Order Number: MPC107UMAD/D

Rev. 0, 2/2001

## **Errata to MPC107 PCI Bridge/Memory Controller User's Manual, rev. 0**

**Figure 3-3. PCI I/O Master Address Map B**

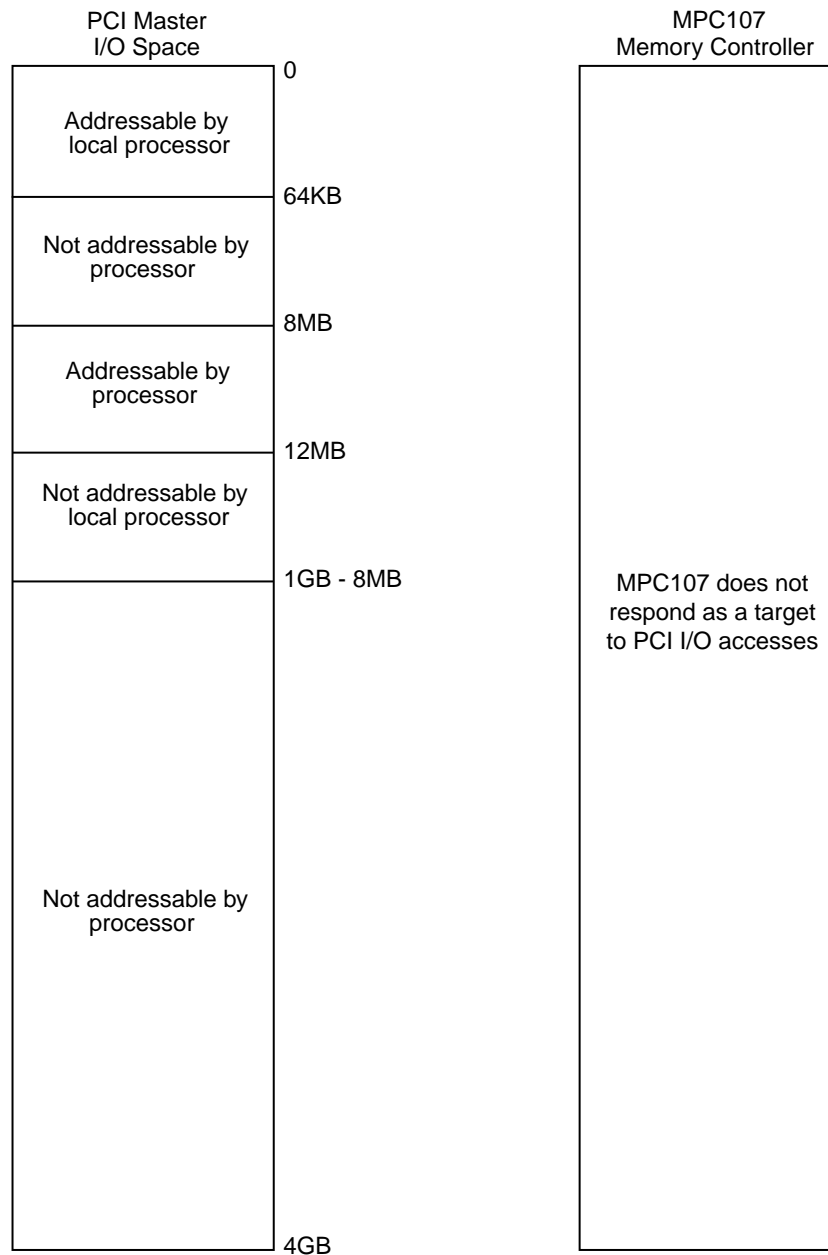
3.1, 3-7

Replace Figure 3-3 with the following:

**Figure 4–30. Memory Control Configuration Register 2 (MCCR2)—0xF4**

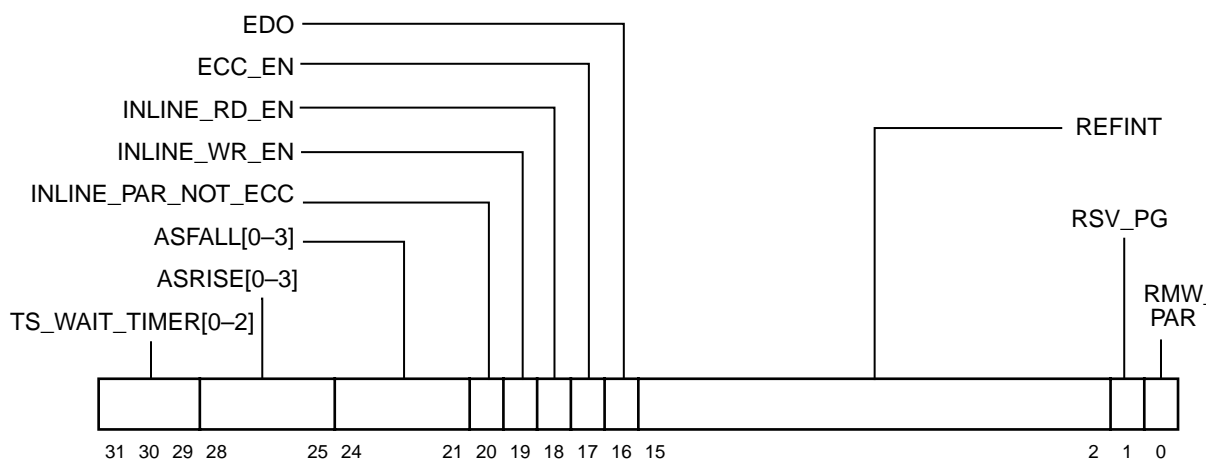
4.10, 4–47

Replace Figure 4–30 with the following. Note the name change to bit 18.
